DESIGN COMMISSION
MONDAY, OCTOBER 27, 2014 6:00 PM
AUSTIN CITY HALL, BOARDS AND COMMISSIONS ROOM 1101
301 W. SECOND STREET, AUSTIN, TEXAS 78701

5th & Brazos

Re: Working Group review of 5th & Brazos Hotel for substantial compliance with the Urban Design Guidelines

GROUND LEVEL PLAN - LANDSCAPE (GREAT STREETS LAYOUT)

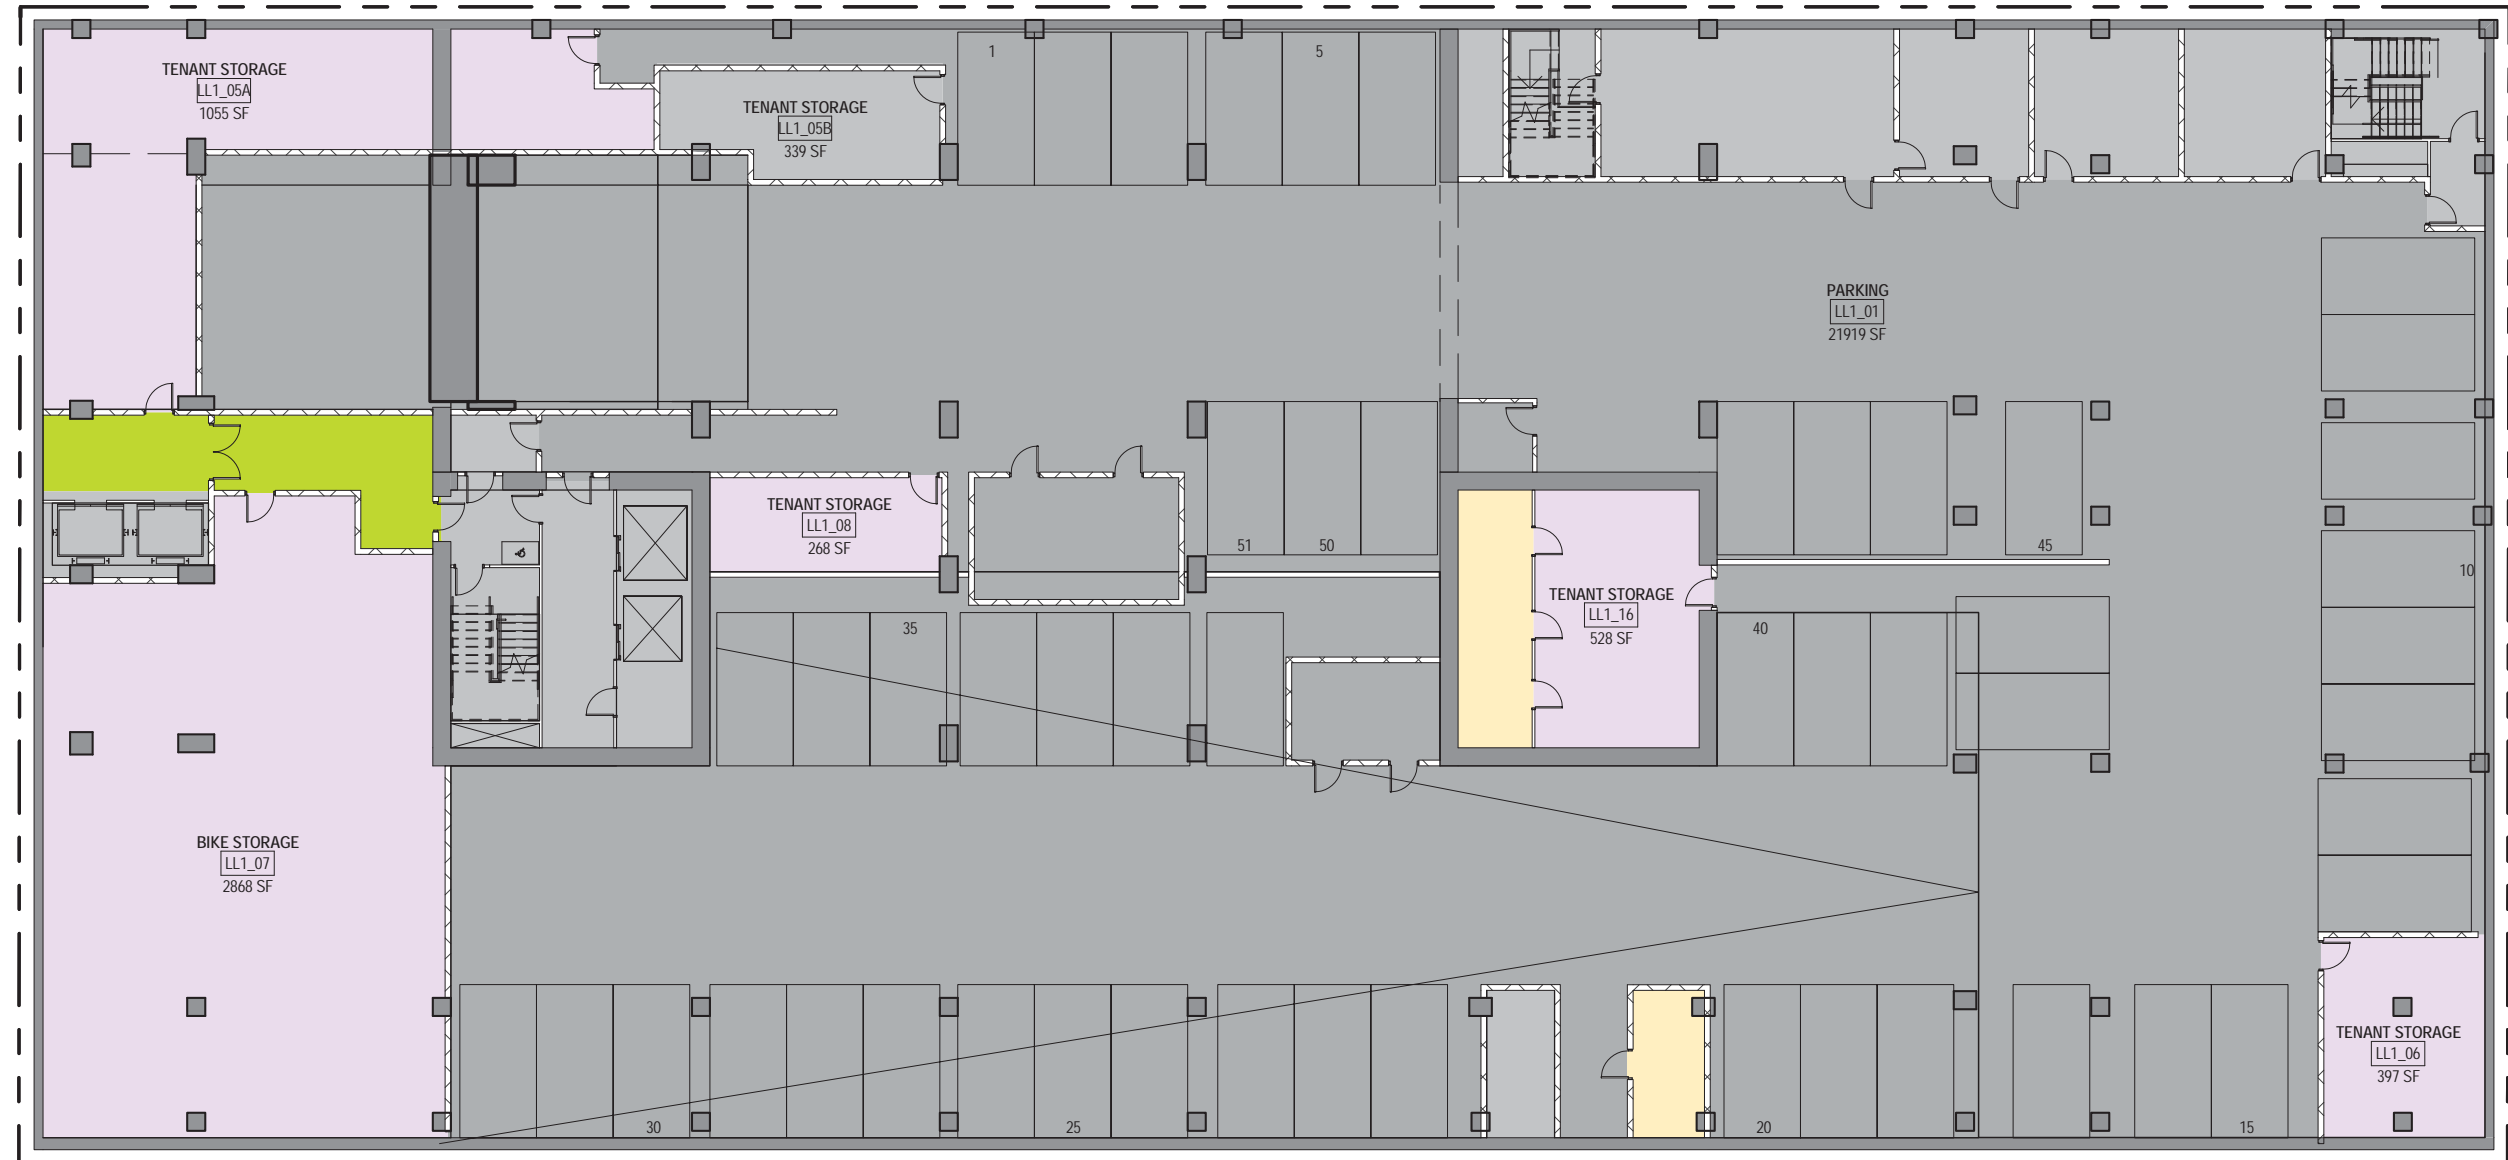
1. Kitchen placement is along the active portion of the ground floor façade at East 5th Street.
2. Driveway should have a character to help pedestrians realize that there is a change of function of what they are walking on – for safety concerns.

4. If possible add a tree at the corner where the driveway is adjacent to the alley.
5. Back of house area for the ballroom – add some windows instead of blank wall. Helps with ambient light and less reliance on electricity. Can be high windows if needed.
